ADDENDUM #1
INVITATION FOR BID #23-100

**TRANSPORTATION IMPROVEMENTS FOR PETTEE SQUARE –
OAK STREET & CHESTNUT STREET**

THIS ADDENDUM IS TO: ANSWER THE FOLLOWING QUESTIONS, PROVIDE NEW ITEM SHEETS and PROVIDE UPDATED CONSTRUCTION SPECIFICATIONS.

STRUCTURAL SOIL
N.T.S.

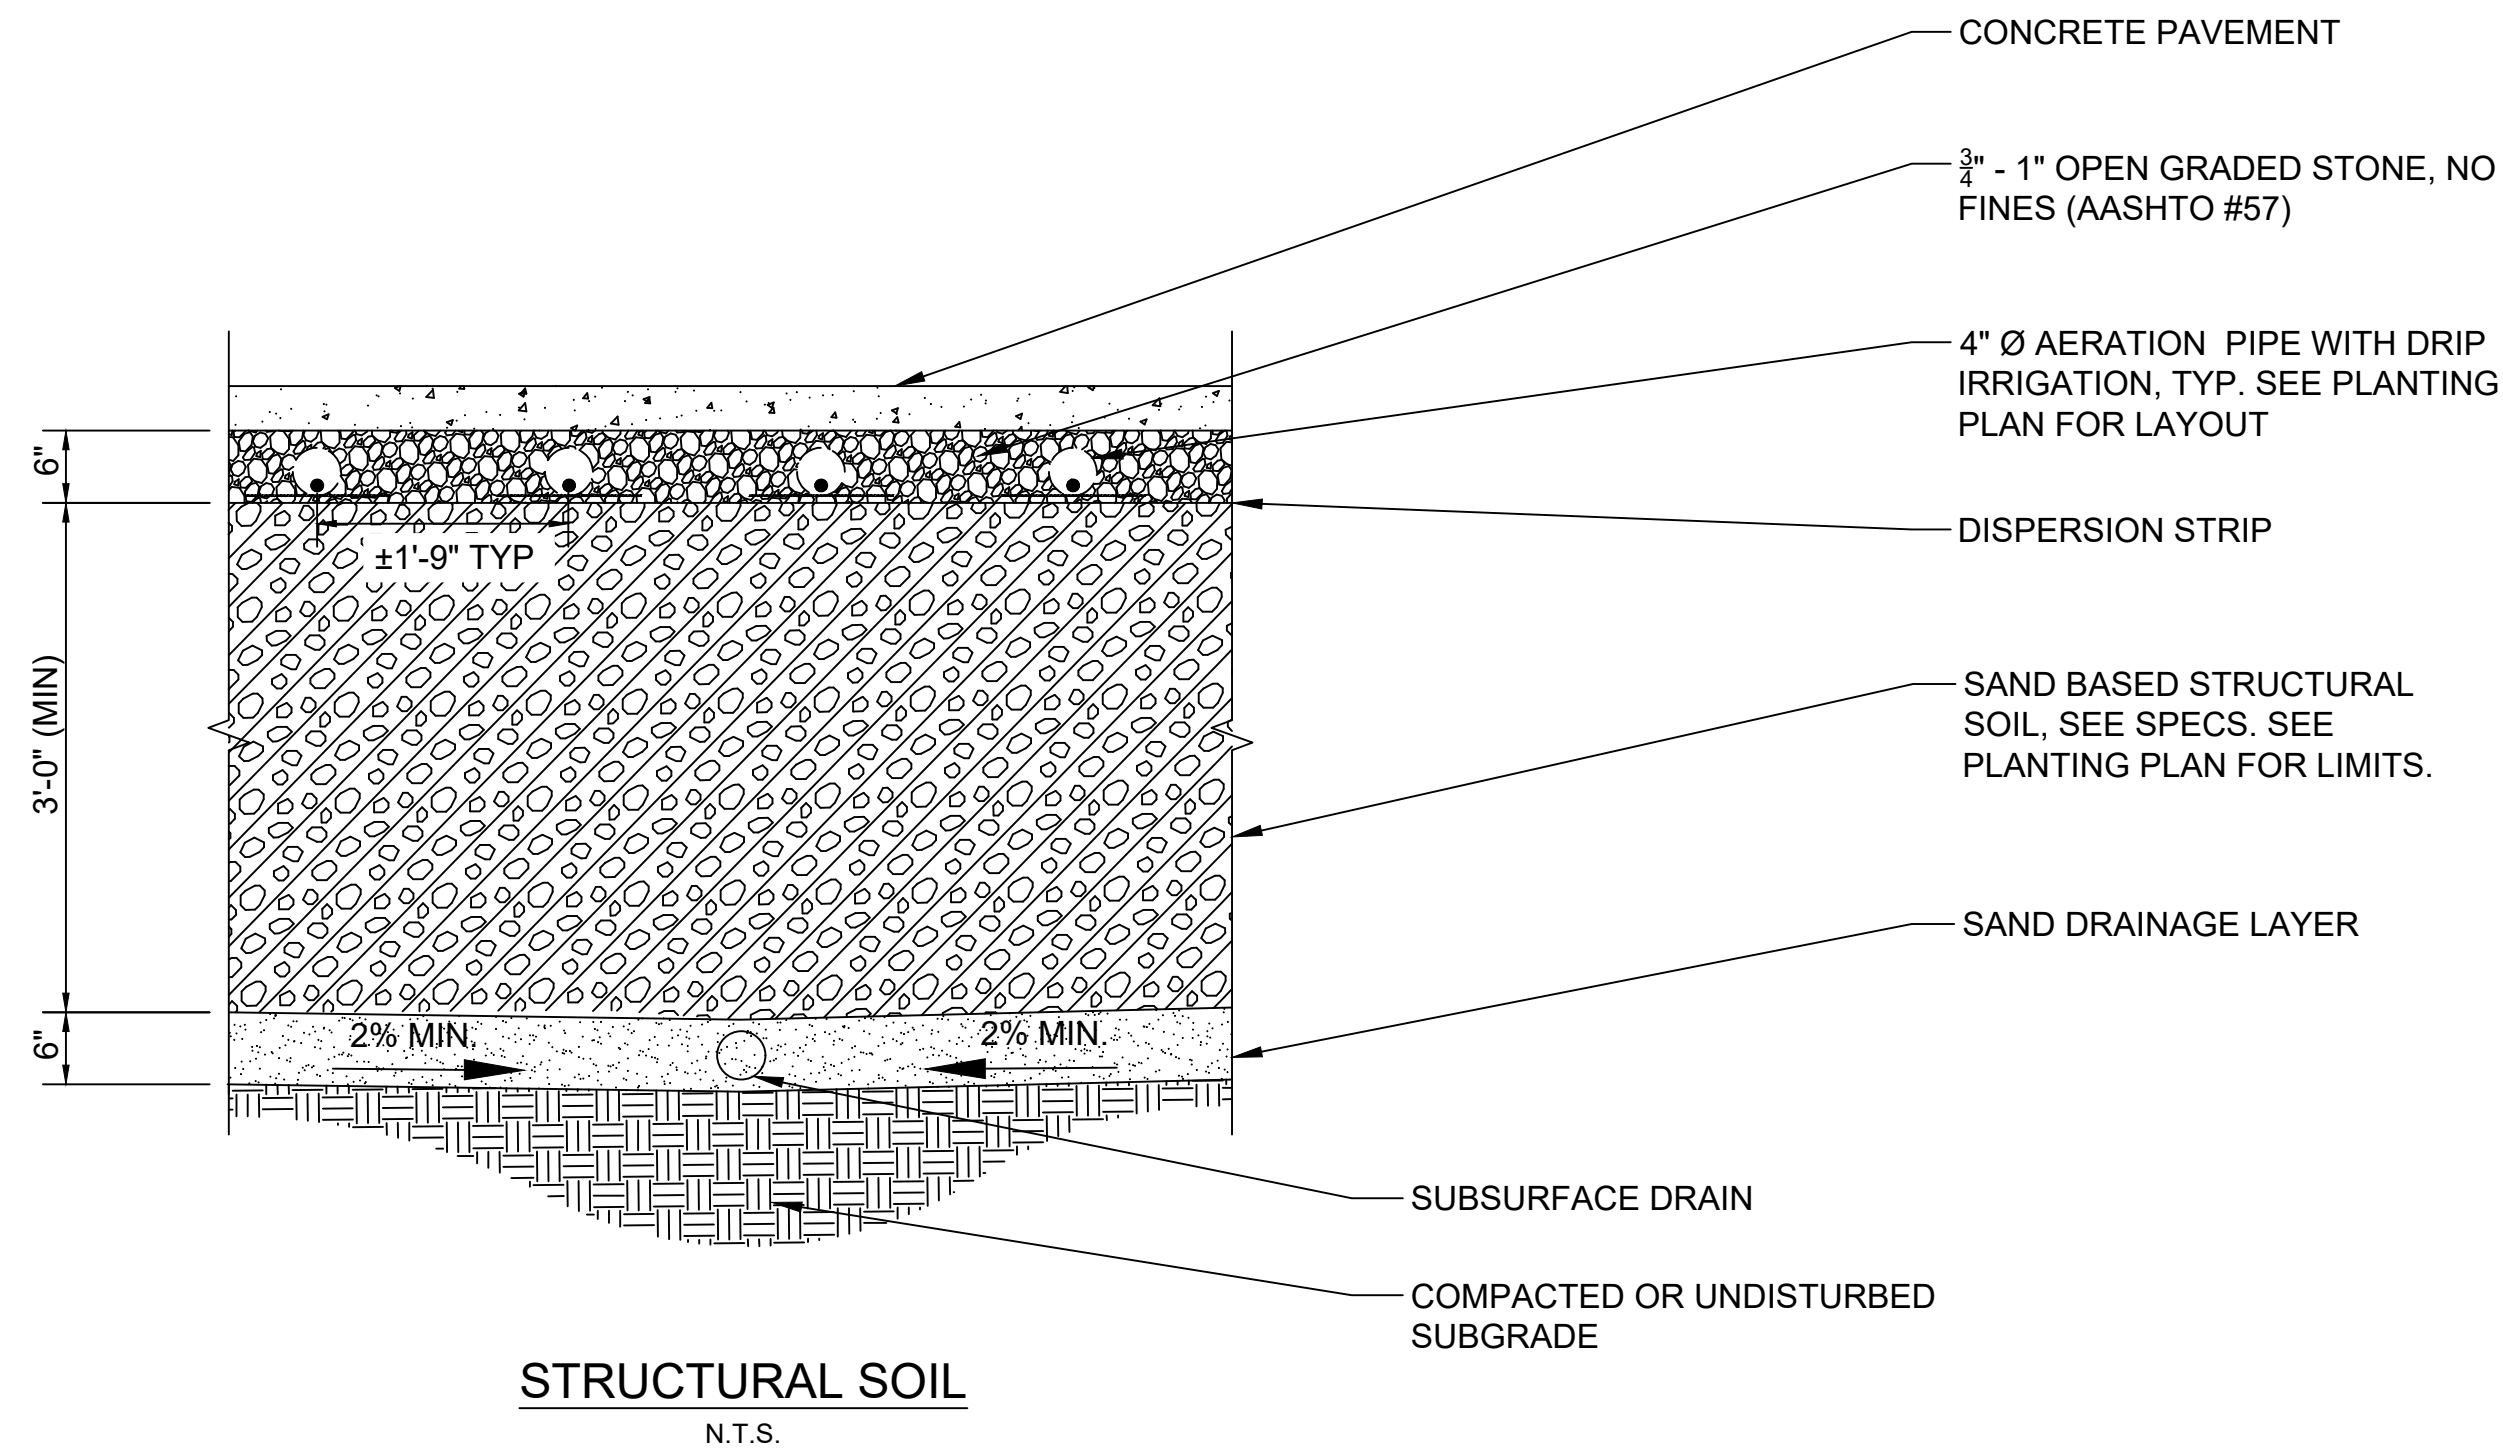
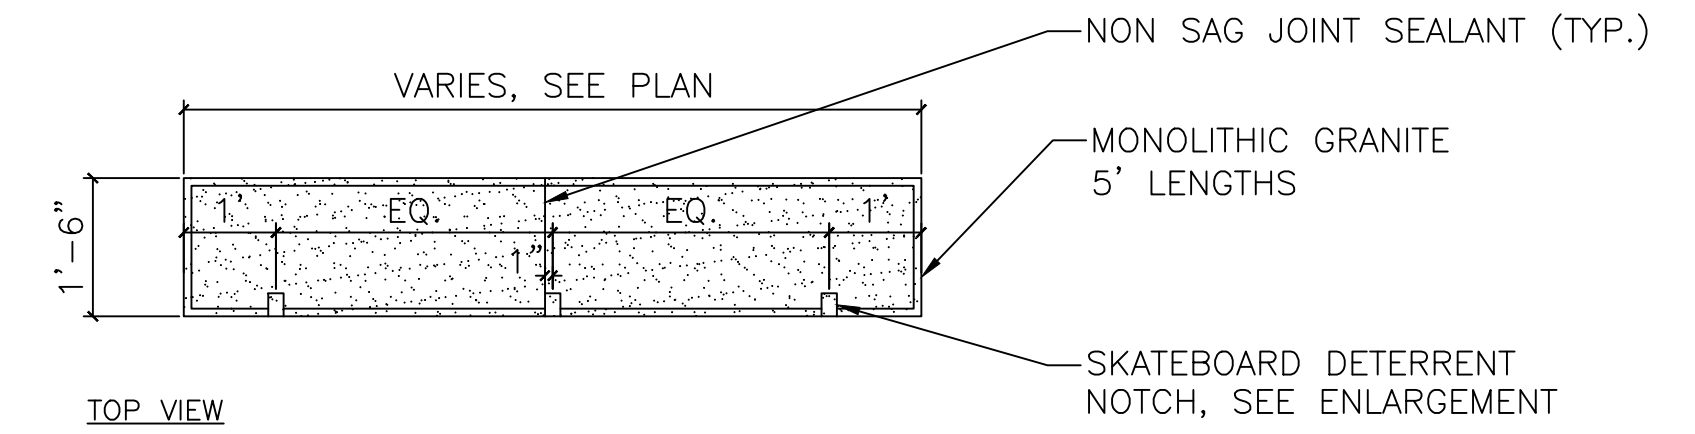
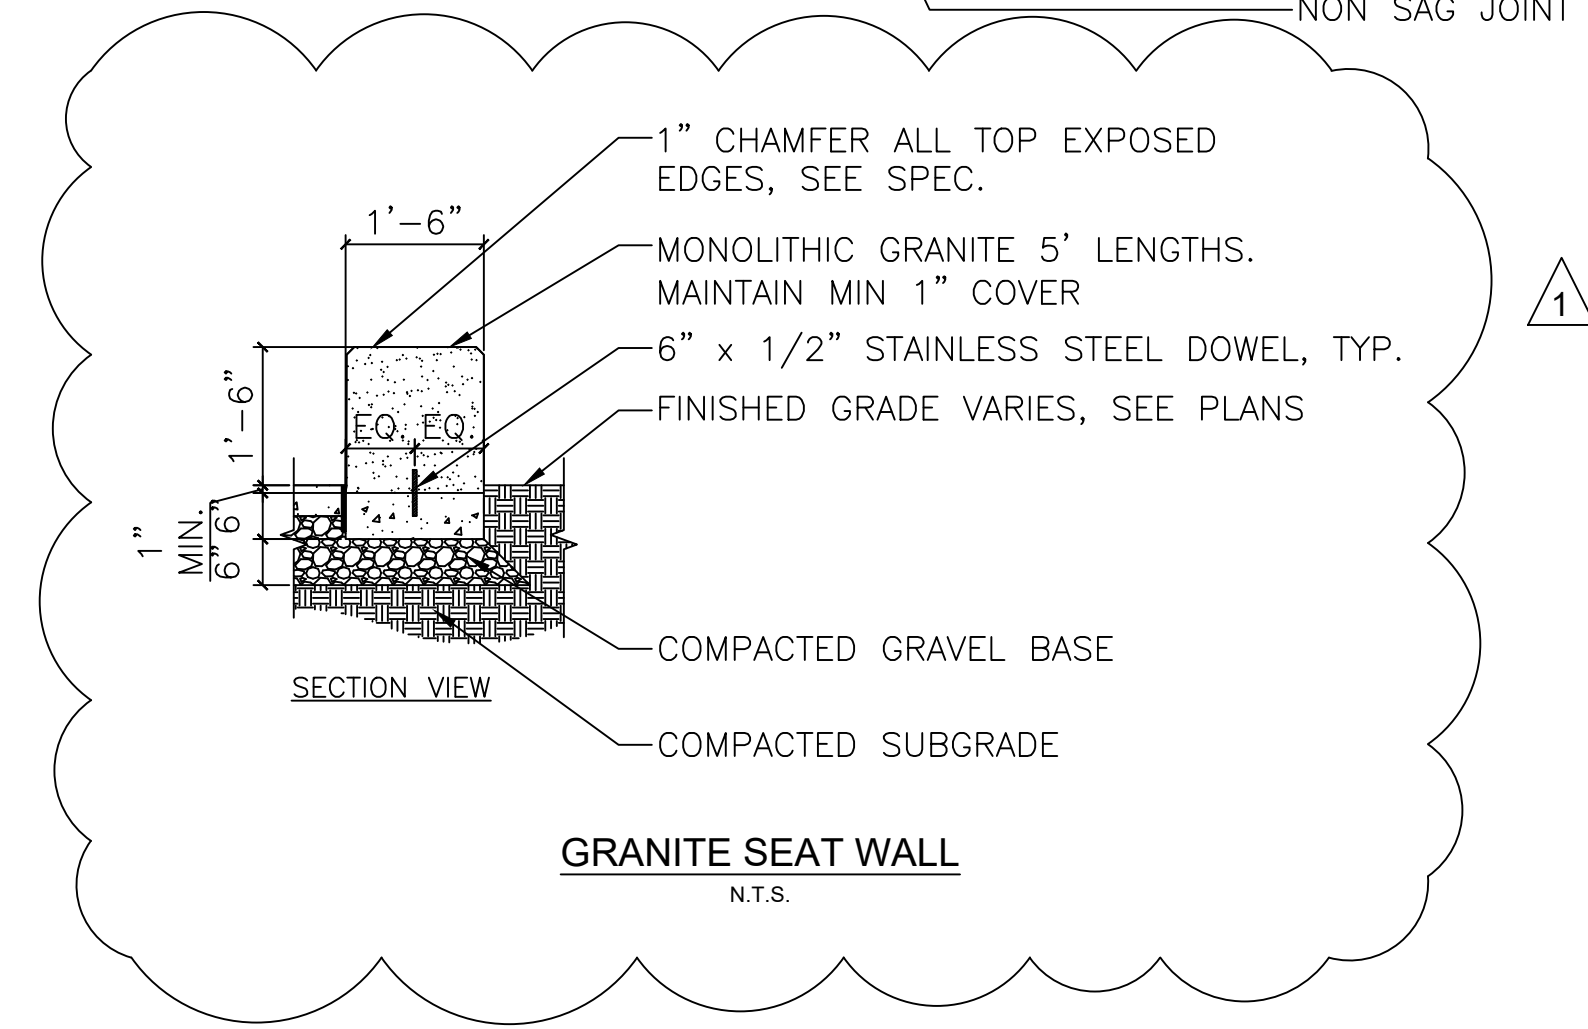
Q2. Under item # 752.51 “structural soil” is the 4” underdrain pipe (multiple run as shown on sheet 35 of 46) being paid under item # 269.04 “ 4” pipe perforated,

A2. 4” underdrain pipe for Item 752.51 is paid for under Item 269.04 – 4 INCH SLOT PERFORATED CORRUGATED PLASTIC PIPE (SUBDRAIN). The bid quantity has been updated in the new Item Sheets, attached.
